- ◇ Baptiste Vandercrux
- Xavier Fettweis
- Max Stevens

We would like to thank the editor and reviewers for their detailed and constructive comments. Please find below our actions and responses, grouped by comment type and section. The reviewer's name corresponds to the symbol used, see above.

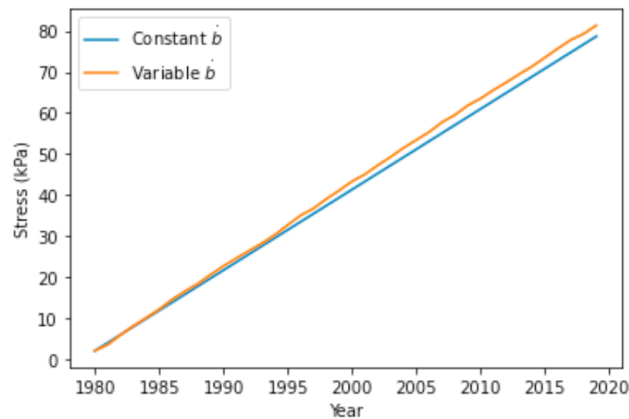
- Equation 3: **Does  $\bar{b}$  evolve through time based on changing accumulation rates through time, or is it constant for a given site based on the spin up climate?** If the latter, why? Imagine a site that has warmed since 1980; why should the densification rate of snow that fell in e.g. 2010 be dependent on the accumulation rate from decades earlier when the climate was different? Arthern et al. (2010) formulated their model equation using a steady-accumulation assumption (see their Appendix B); is it appropriate to use your densification equation with variable accumulation, either climatic variability or changing climate? **Why not just formulate your model in terms of the stress?**

Here, we take  $\bar{b}$  as a constant. It is equal to the mean annual accumulation during the spin-up period (1960-1980), as this period is the climate in which the firn layer is assumed to be in equilibrium. The actual stress  $\sigma(t)$  that a firn layer of age  $t_{\text{age}}$  "feels" (in the absence of melt) is given by:

Taking  $\dot{b}(t)$  as a constant is an approximation that simplifies the densification rate, but the uncertainty this introduces is minor. This can be demonstrated by considering a hypothetical layer of firn that is deposited right after the spin-up ends at Summit. Now we can compare the stress of on this layer if we use a constant  $\dot{b}$  or calculate the stress using the equation above. The evolution of the stress is shown in the figure below:

The error grows over time. At the end of 2020 the error is equal to 3.2%. For other locations we obtain similar results (e.g. for Dye-2 the error is 1.9%). This error is small enough to justify this approach for the timescale considered. However, we acknowledge that for larger time scales, such as for future runs, this approach may no longer be valid. Therefore, we plan to make appropriate adjustments to the model before doing such runs. We have added a short paragraph to the revised manuscript to summarize our findings presented above.
